**ADDENDUM
NO. 1**

March 3, 2021

Scott County School District 1 – Austin Elementary Additions & Renovations and HS Pool Renovation
Austin, IN 47102

ADDENDUM NO. ONE

WALL SECTIONS

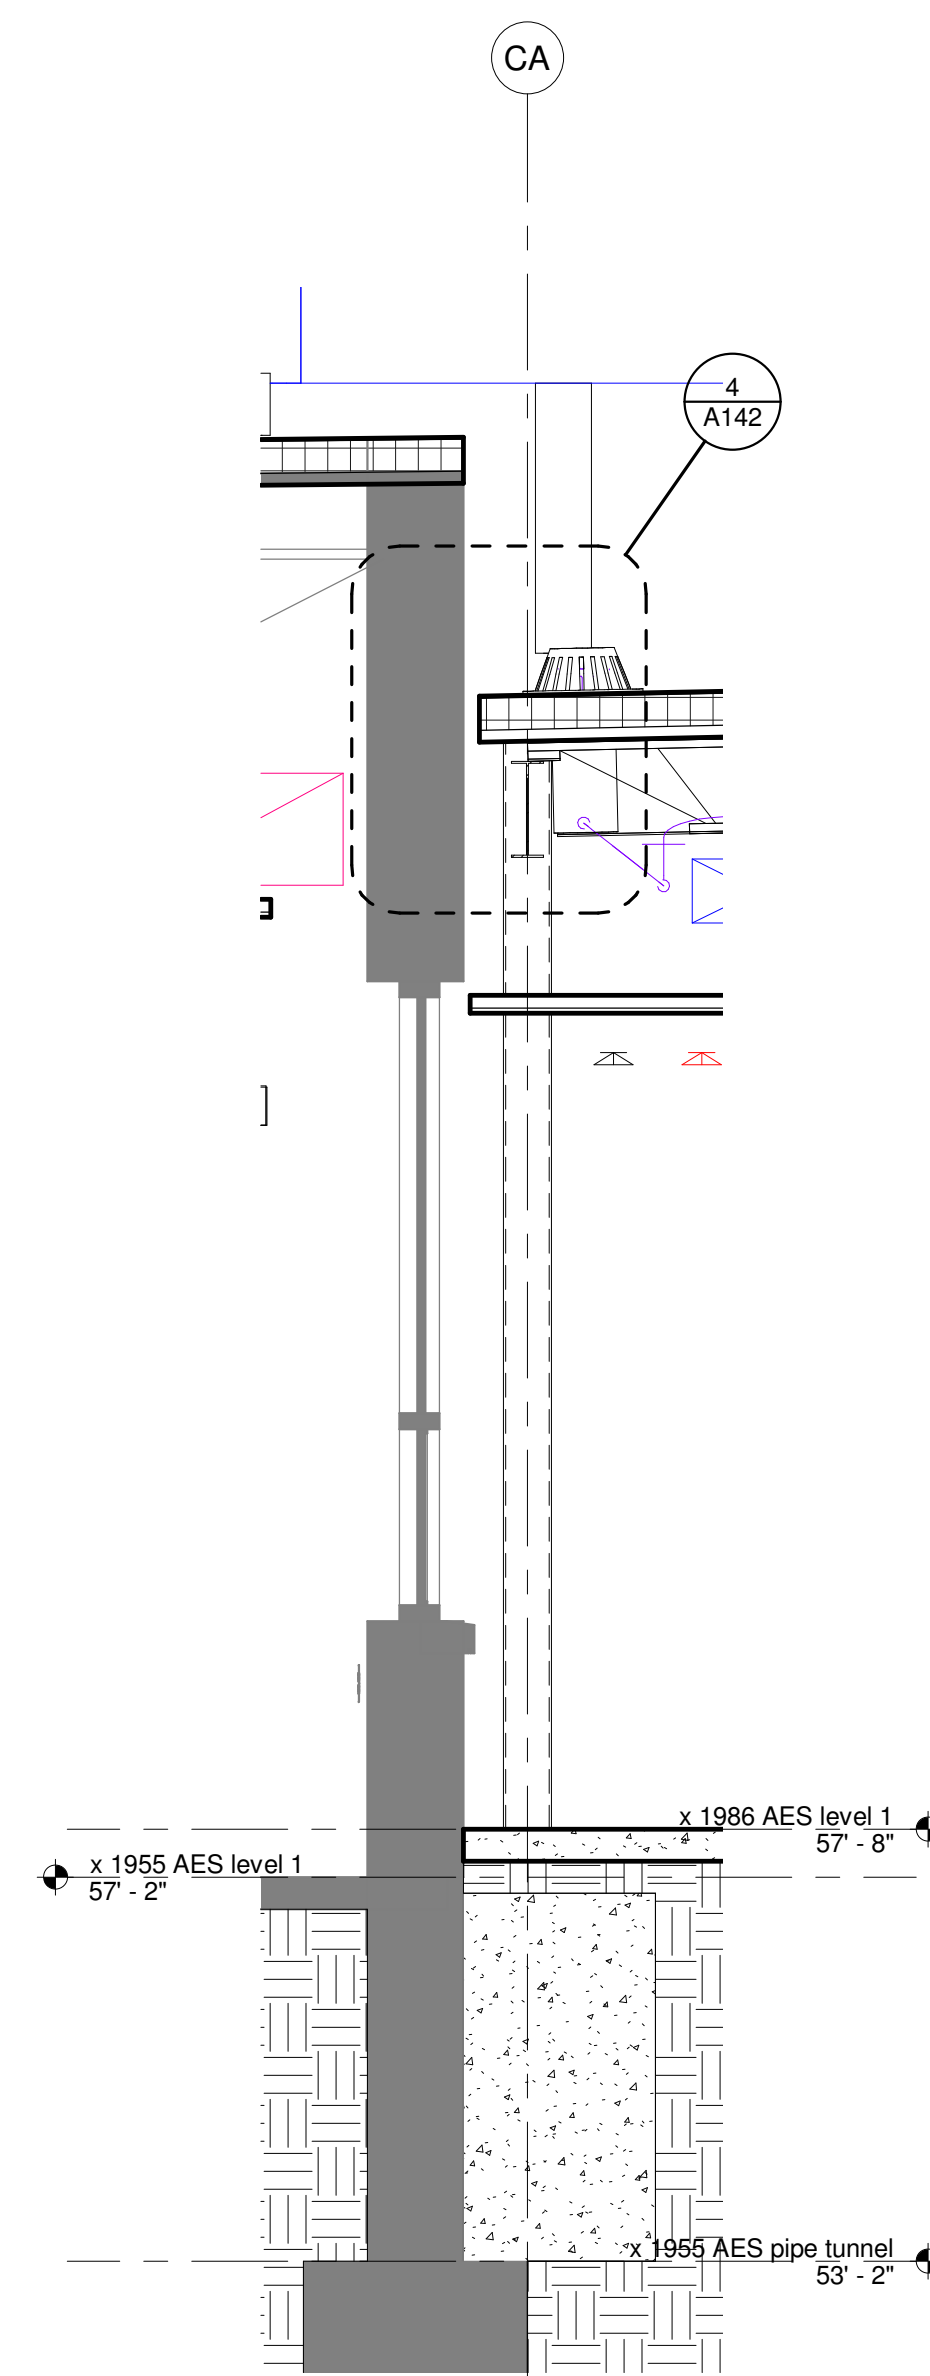
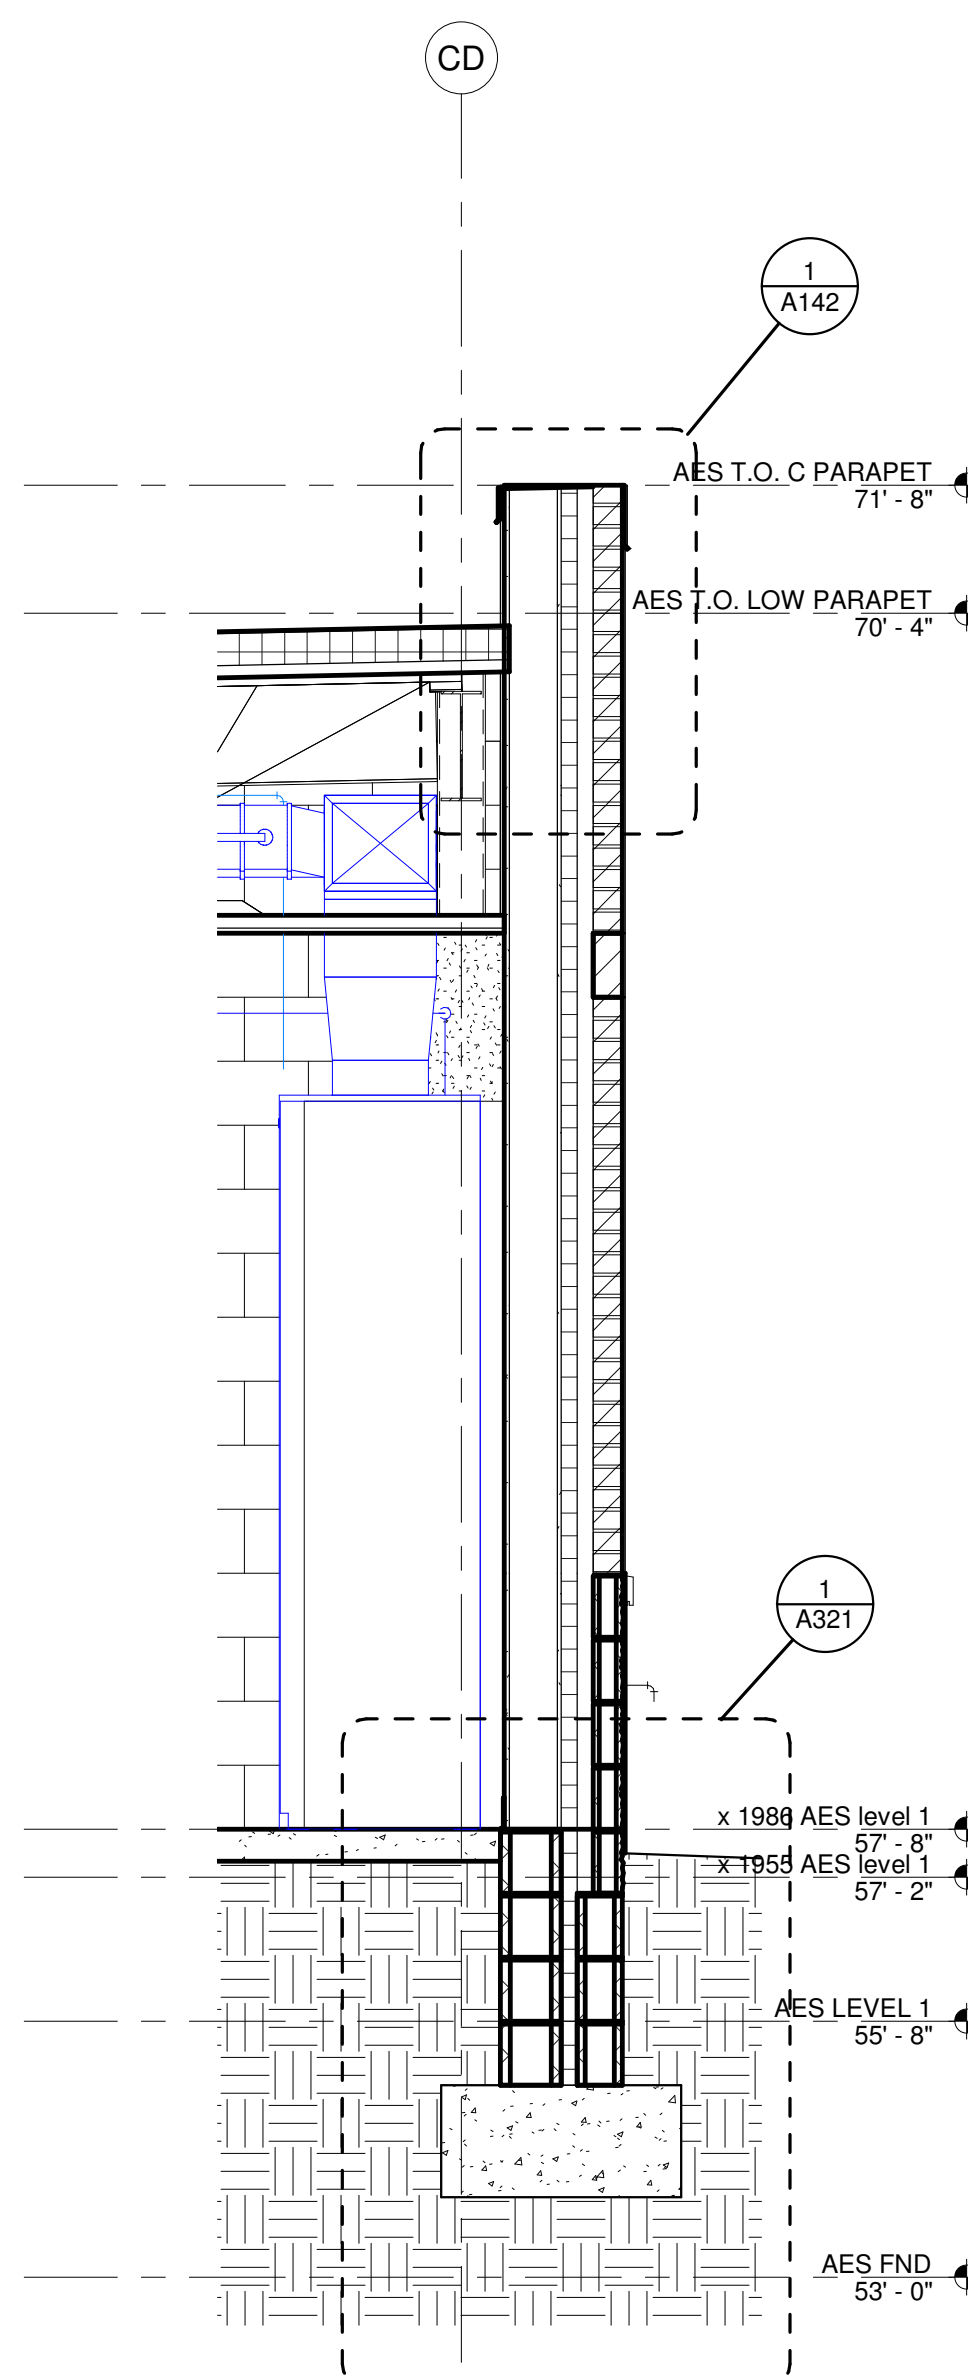
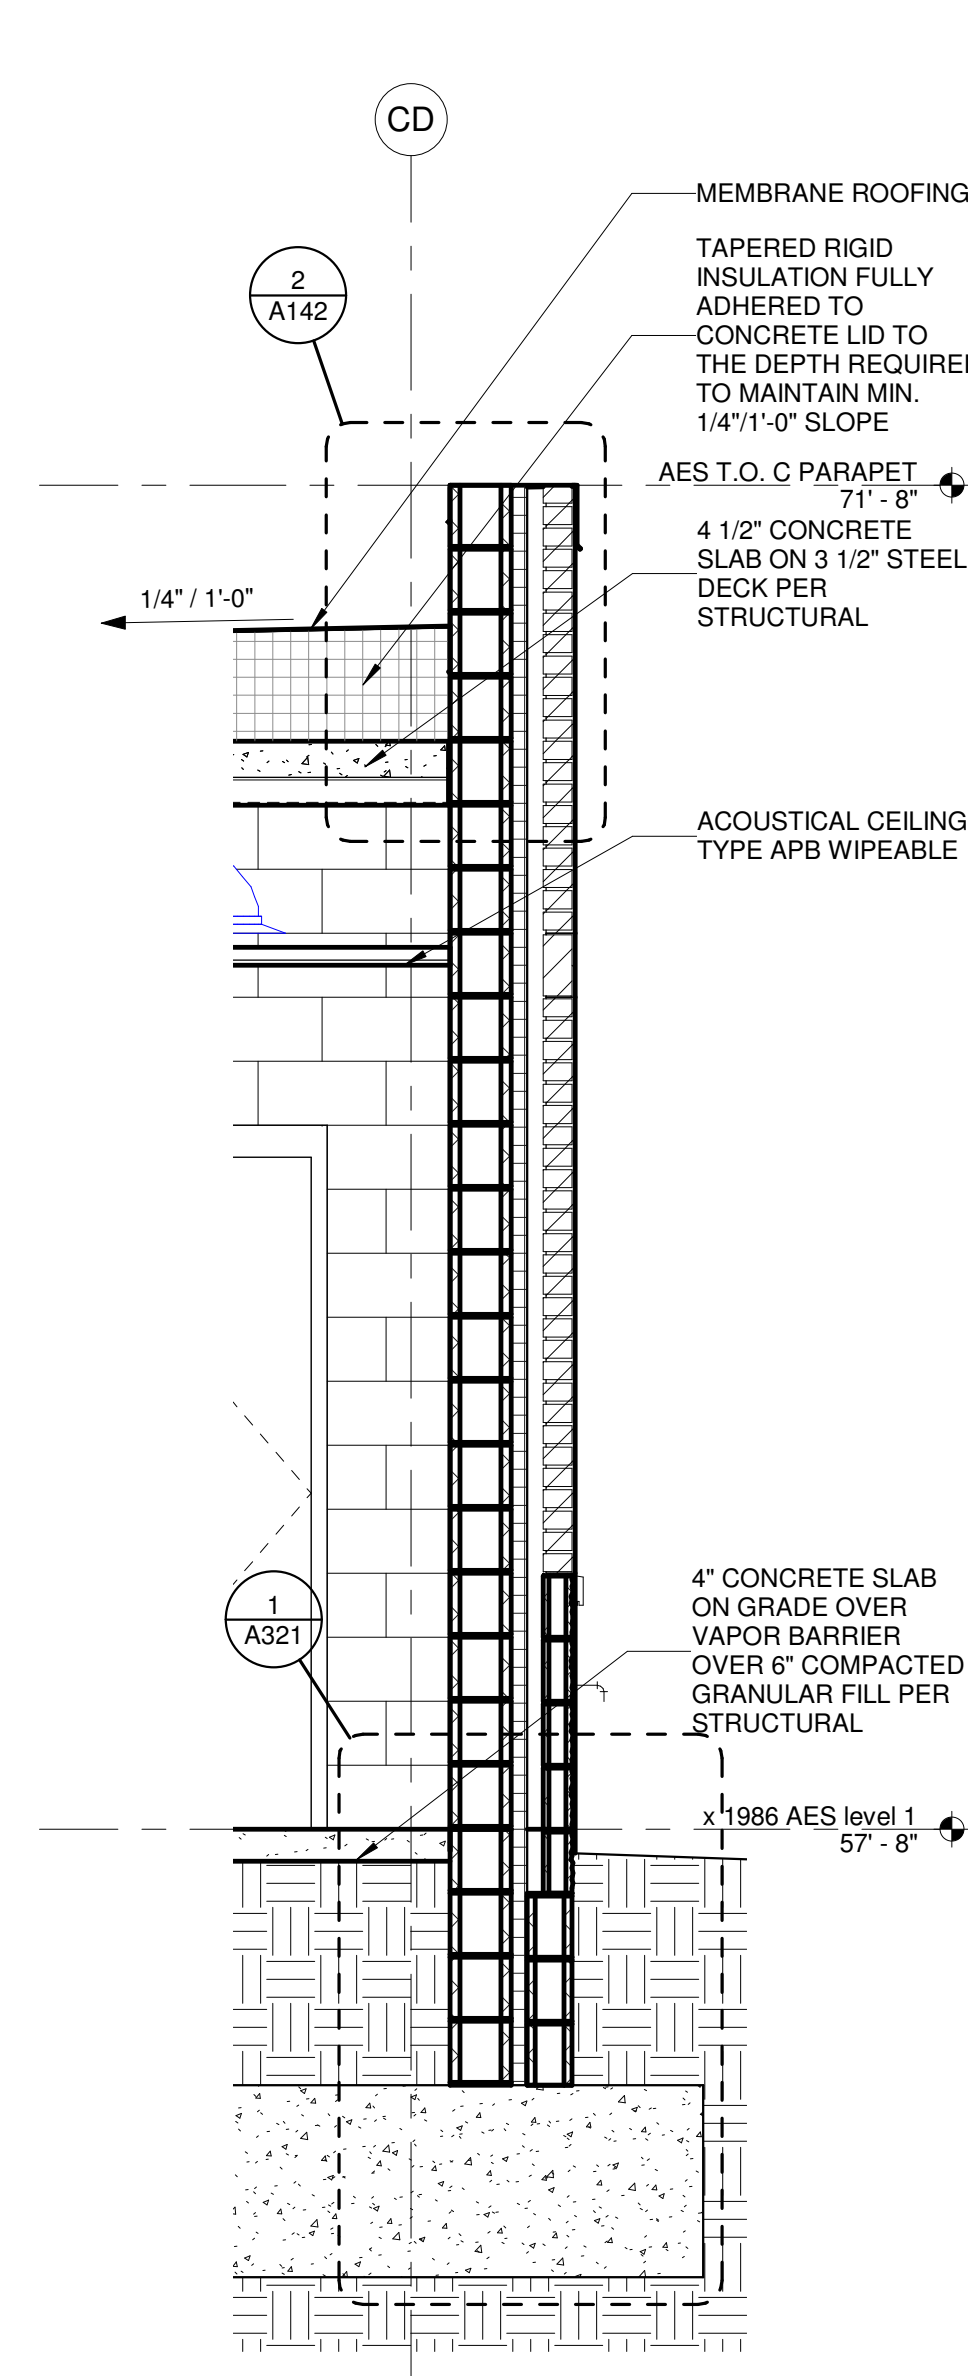
10. Drawing No.: A313
Drawing Sheet Title: WALL SECTIONS
Revision:
Modified Unit D Corridor addition structure and parapet height at detail 1 on attached revised sheet.
